Access Compliance Report Public Rights-of-Way (Curb Ramps)

Intersection ID: 11313 Main Street: STAFFORD DR Cross Street: WILKINSON_BV Location: SW **Overall Compliance: No** ADA ID: 10B5ED5BC597 Ramp Type: Perp Initial Pass/Fail: Fail **Severity Score:** 12.5

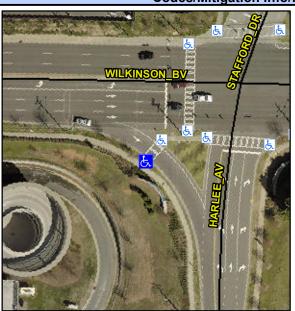
Possible Solutions:	Con
Remove & Replace Entire Ramp.	N/A
•	Yes
	N/A
	N/A
	N/A
	N/A
Surveyor Notes:	N/A
N/A	N/A
	N/A
	N/A
	N/A
PROW/ADA:	N/A
Not Found, R304.2.2	N/A
·	N/A
	N/A
	N/A

Field Measurements/Component Compliance							
Comp	liance Description	Data	Comp	liance Description	Data		
N/A	Ramp Length (in)	72.0	No	Ramp Slope (%)	8.9		
Yes	Ramp Width (in)	63.0	Yes	Ramp XSlope (%)	0.6		
N/A	Flare Type LT	N/A	N/A	Flare Type RT	N/A		
N/A	Flare Slope LT (%)	N/A	N/A	Flare Slope RT (%)	N/A		
N/A	Flare Traversable LT?	N/A	N/A	Flare Traversable RT?	N/A		
N/A	Landing Length (in)	N/A	N/A	DWS Provided?	N/A		
N/A	Landing Width (in)	N/A	N/A	DWS Contrast?	N/A		
N/A	Landing Slope (%)	N/A	N/A	DWS Length (in)	N/A		
N/A	Landing X Slope (%)	N/A	N/A	DWS Full Width?	N/A		
N/A	Landing Curb? (Y/N)	N/A	N/A	DWS Offset (in)	N/A		
N/A	Shared Landing?	N/A					
N/A	Gutter Ponding?	N/A	N/A	Gutter Slope (%)	N/A		
N/A	Gutter Lip Ht (in)	N/A	N/A	Gutter X Slope (%)	N/A		
N/A	Painted X Walk1?	Yes	N/A	Painted X Walk2?	N/A		
	X Walk 1 Direction	To NE		X Walk 2 Direction	N/A		
N/A	X Walk 1 Width (in)	112.0	N/A	X Walk 2 Width (in)	N/A
